December 1, 2014

Re: Expanded Heat Removal Pilot Study
Bridgeton Landfill, Bridgeton, Missouri
Permit No. 0118912

This letter is in response to a Missouri Department of Natural Resources (MDNR) letter dated August 25, 2014 and the Expanded Heat Removal Pilot Study section of a September 4, 2014 letter. The MDNR letter requested additional information with regards to the planned Expanded Heat Extraction Pilot Study at the Bridgeton Landfill (BL). A point by point response has been provided below.

GIW-4 (MODIFIED FOR HEAT REMOVAL)

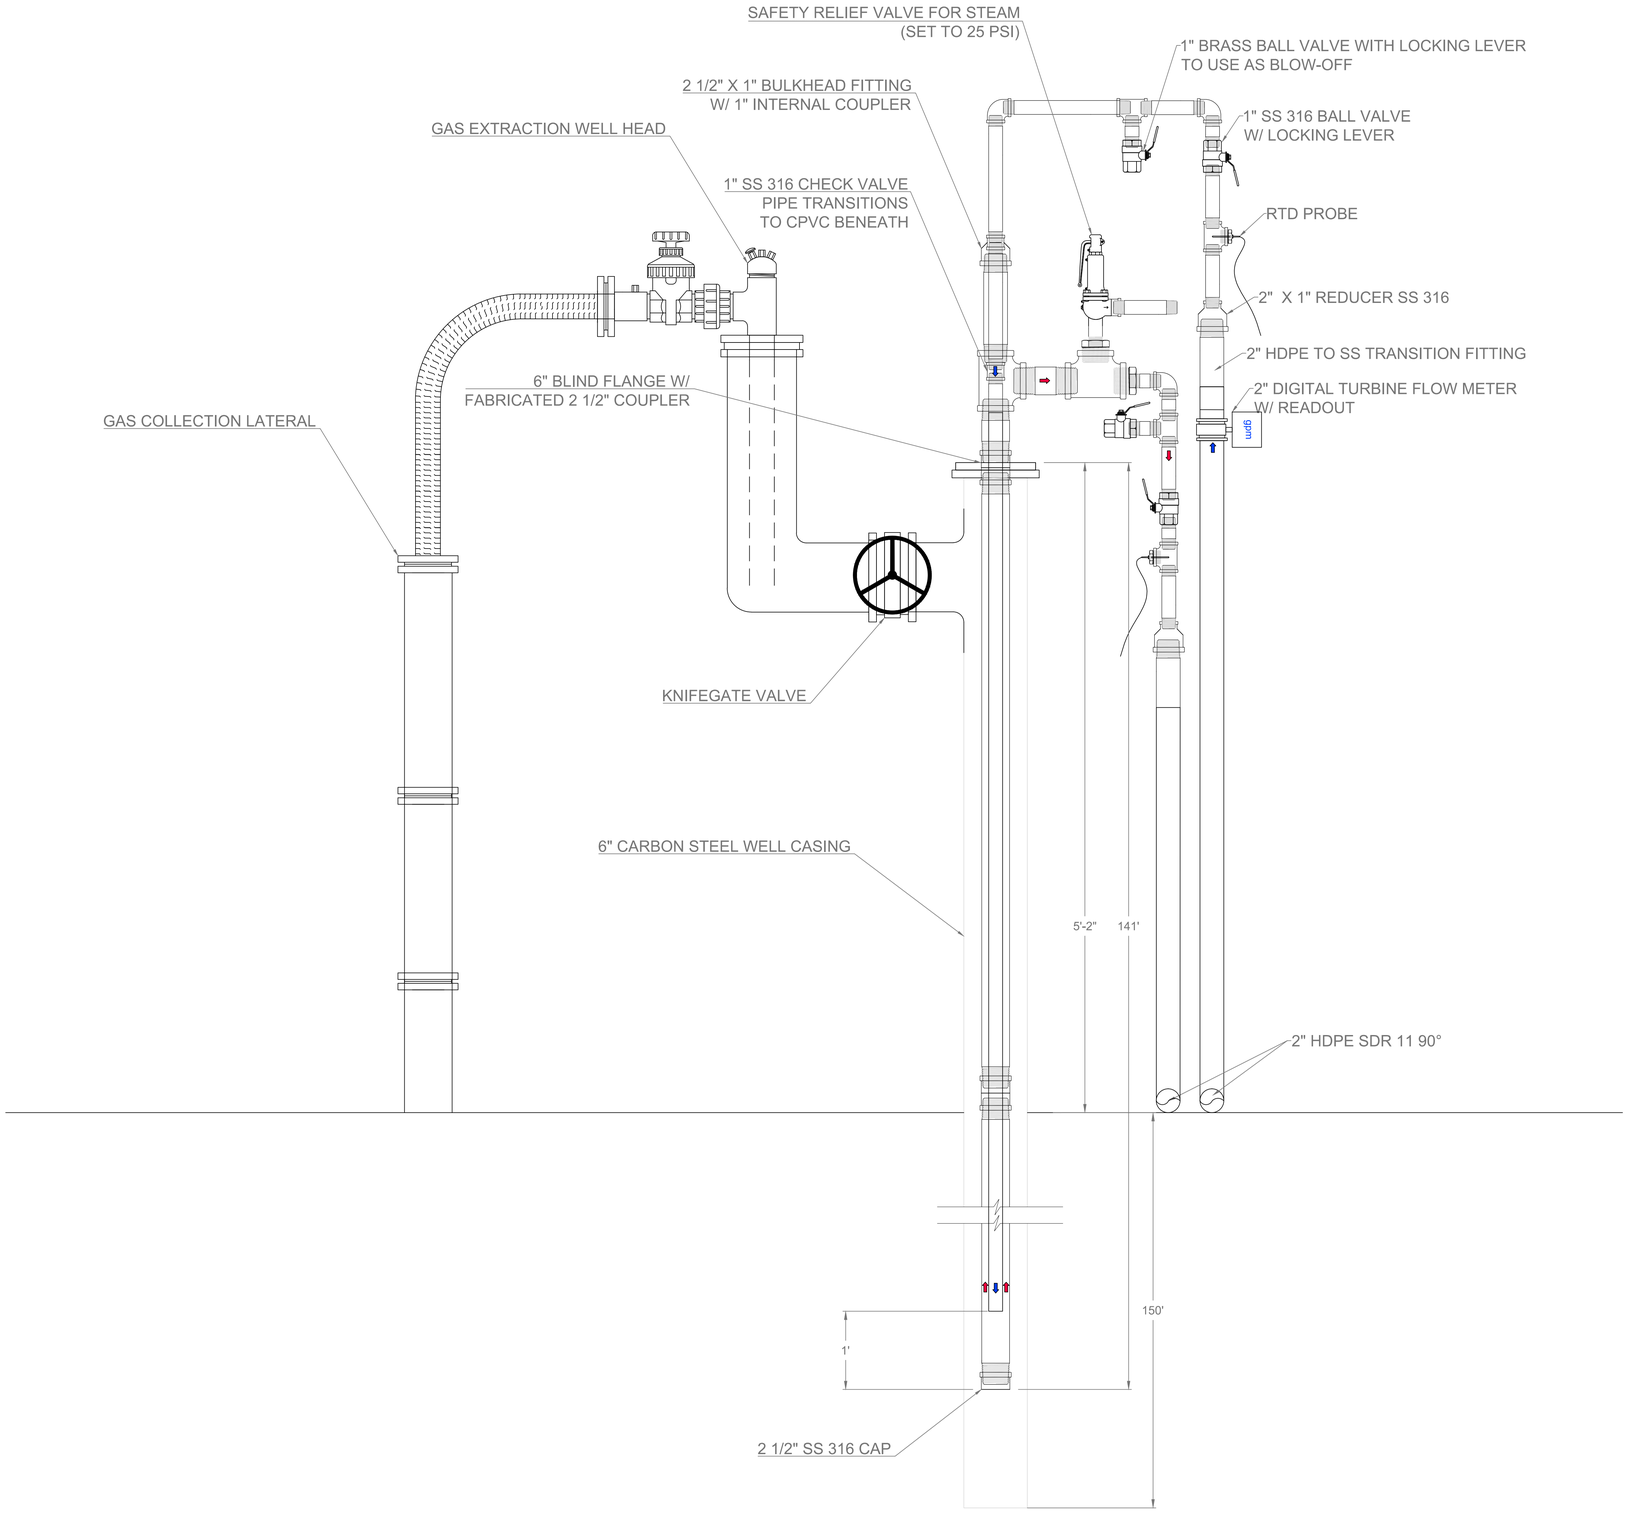
In September of 2013, Gas Interceptor Well (GIW)-4 was modified to remove heat through the circulation of water in a closed loop within the well. The as-built representing the heat removal modification to GIW-4 has been included as Attachment 1 (GIW-4 Modified for Heat Removal).

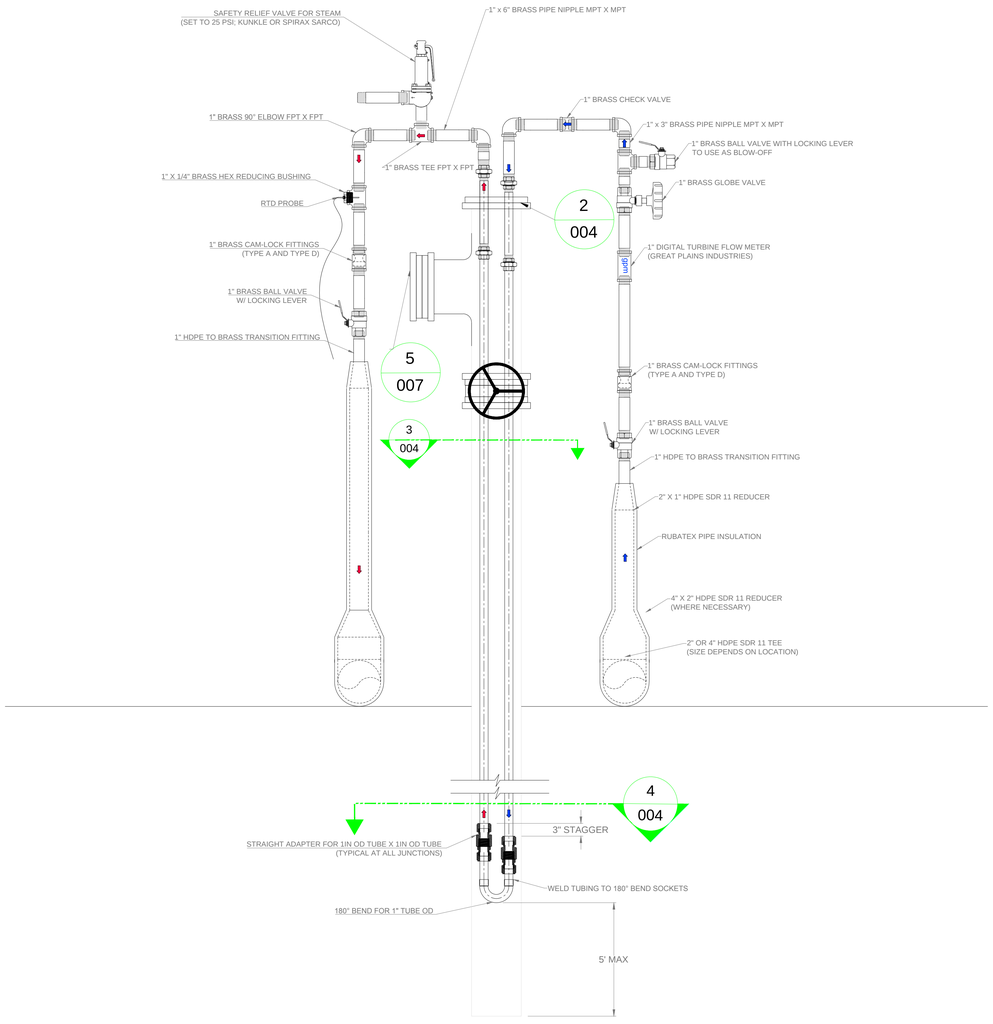
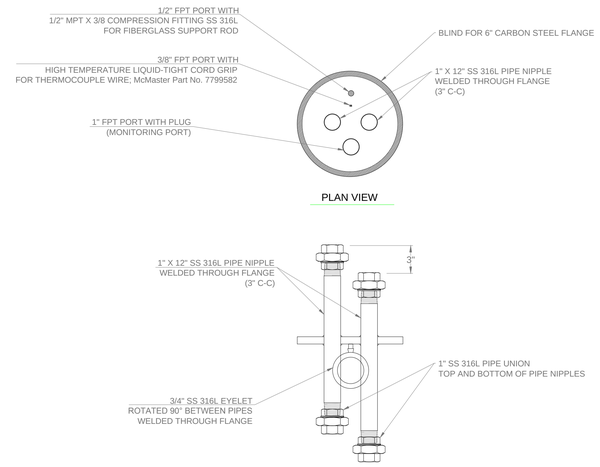
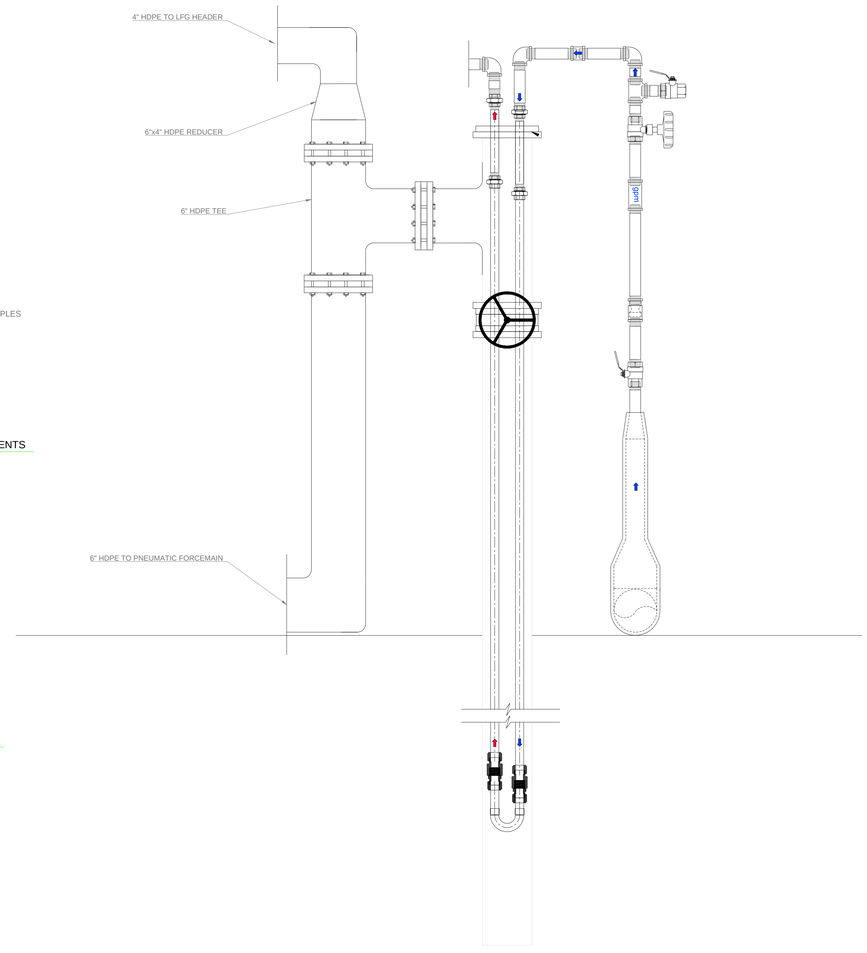
MDNR Comment 19: If the modified GIWs continue to operate as interceptor wells after modification, please provide a detailed construction drawing for the modified GIWs including the cooling loop size, length, bore diameter, depth to water and identify all vacuum lines and connections.

MDNR Comment 22: Is the U-tube heat extraction pipe purchased pre-assembled or assembled on site? The drawing shows both stainless steel connectors and a u-tube welded to the pipe. Please clarify, if both the connectors and welding will be used or if a single type of connection has been selected for the balance of the study.

Please find the detail for the modified GIWs to heat extraction points (Heat Extraction Point Detail). As shown in the detail, the side flange will be connected to a leachate transport line and landfill gas extraction header. Vacuum will be applied to the well via the connection to the landfill gas header system.

All fittings will be connected in the field excluding the welded fittings connecting the 180° bend to the bend sockets and the stainless steel nipples connected to the top flanges.

Model HH-80 Electric

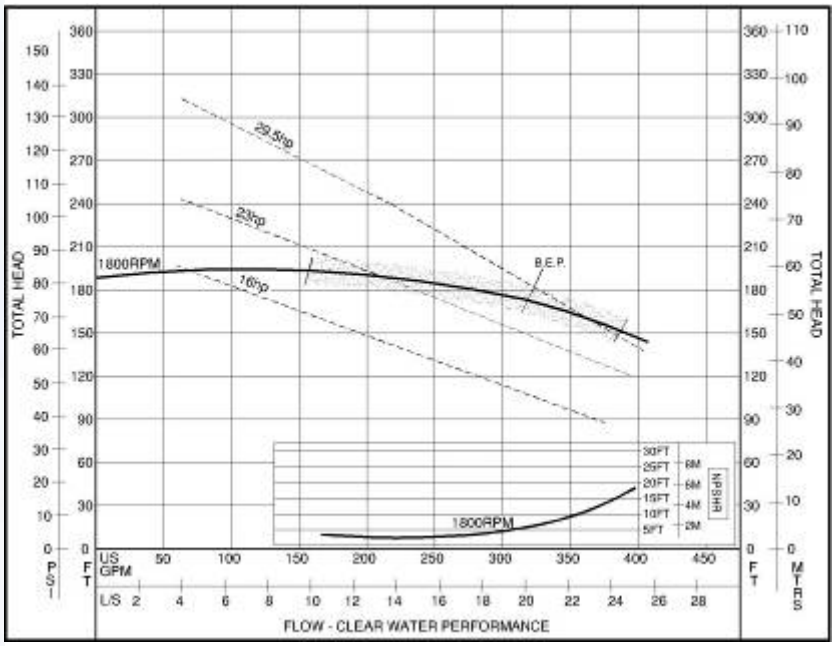
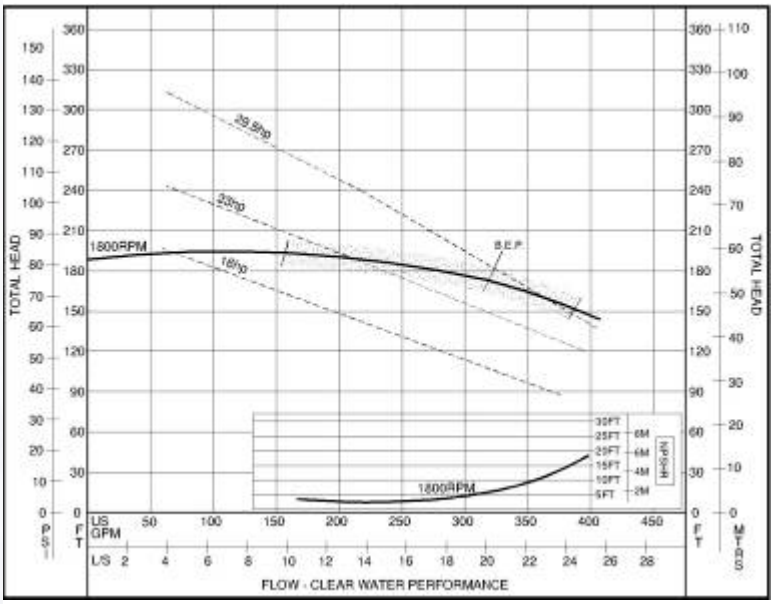
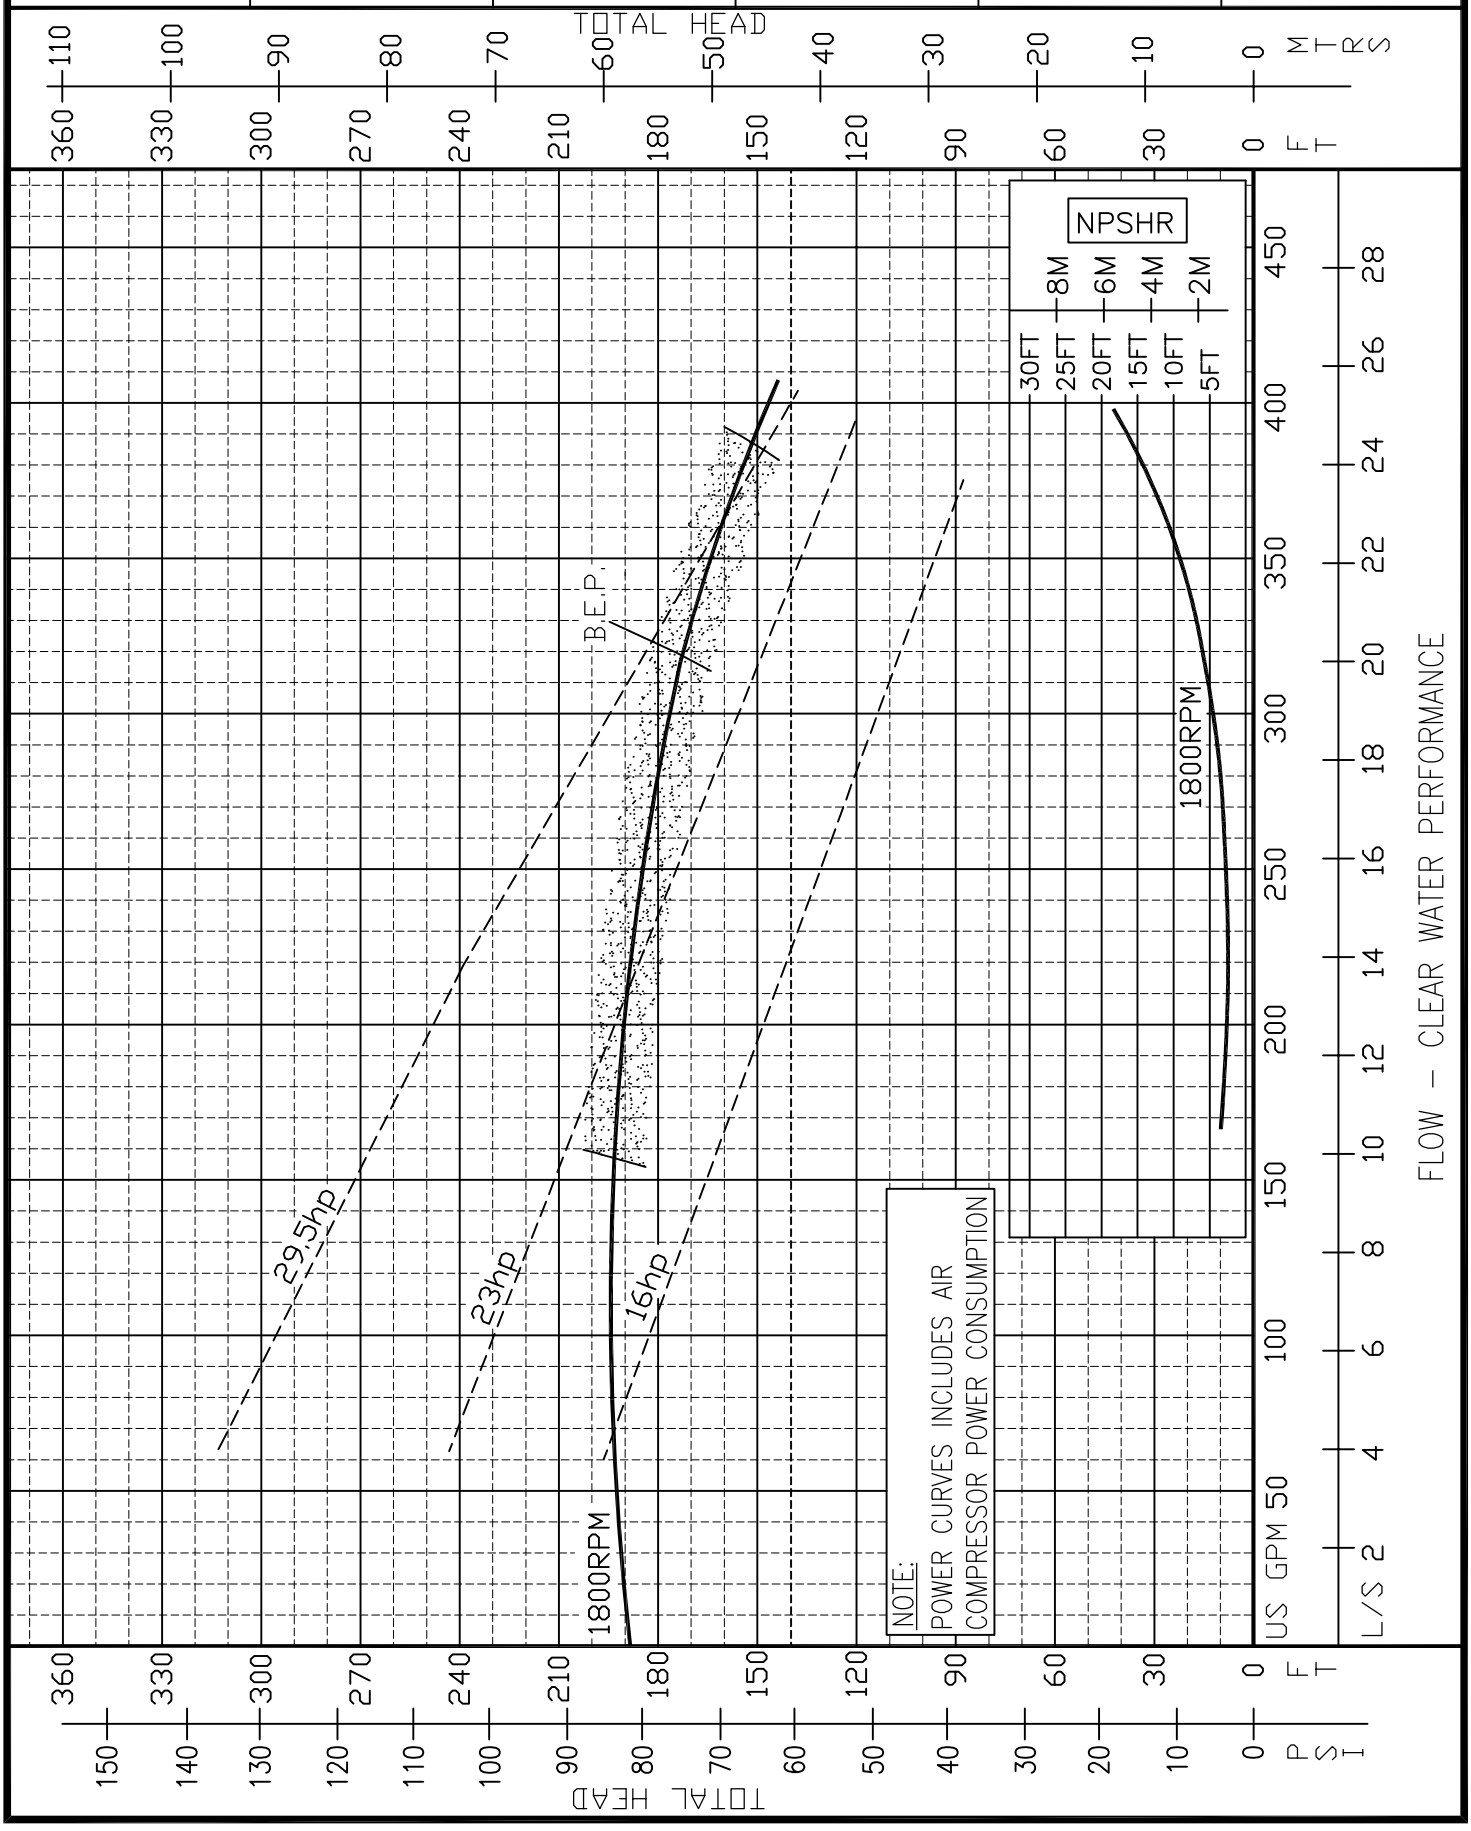
MDNR Comment 16: What is the pump capacity and the expected flow rate to the cooling loops?

The heat extraction system is expected to require 80 to 90 GPM for operation of all 7 points. The selected pump has a design flow rate in excess of design conditions. The pump will be equipped with a variable frequency drive for increased control of flow rate during operations. The Pump Data Sheet supplied by the manufacturer is attached.
